工程指示 / 要求簡箋 ENGINEER INSTRUCTIONS(E.I.)

| 工程指示編號: | EI- 8169 | 修改版本: | - |
| 工程編號: | J 856 | 工程名稱: | 天榮站 |
| 工程項目: | T1 46/F FD門玻璃BM表 | 日期: | 09/08/2024 |

| 制圖 | 劉龍浩 | 2023.10.30 | 圖號 EGL-1A |

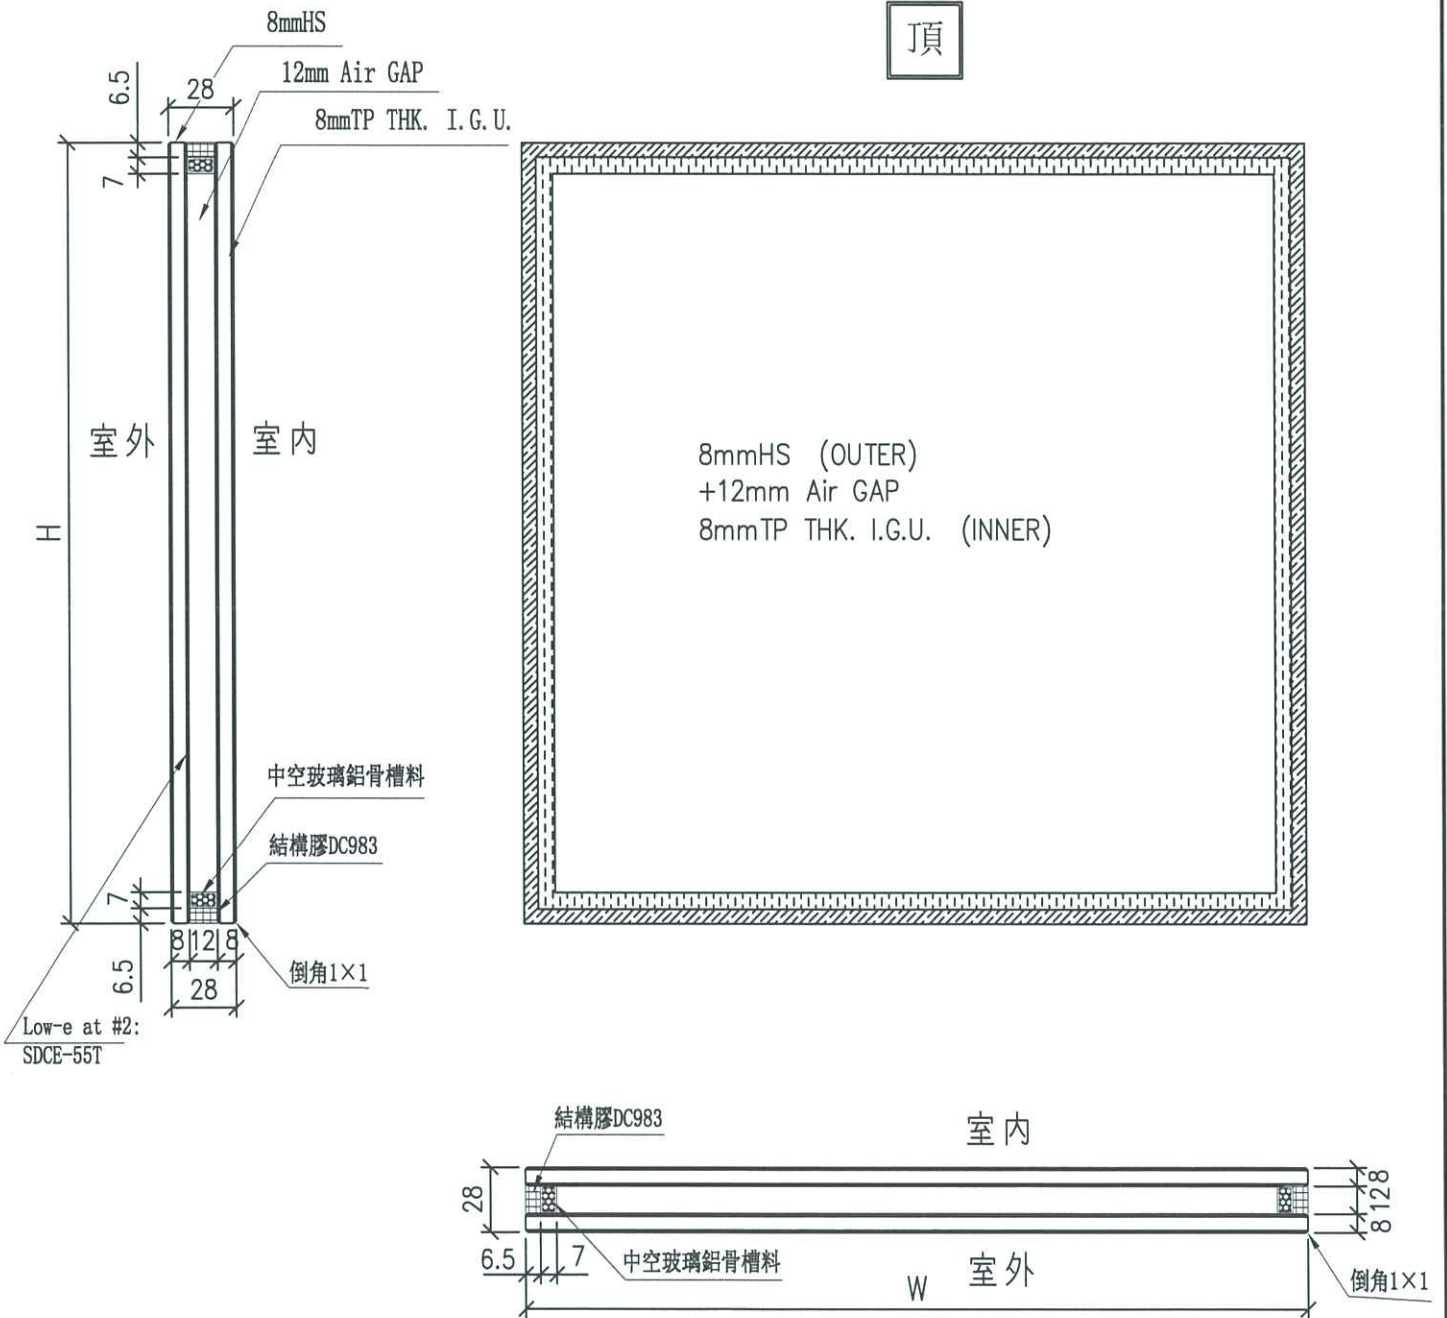
| 內容: T1 46/F FD門玻璃BM表 要做鋼化,需做熱浸 (需T3看熱浸(50%), 新鴻基COW T1(100%)) 完成上列要求日期: 06/09/2024 |
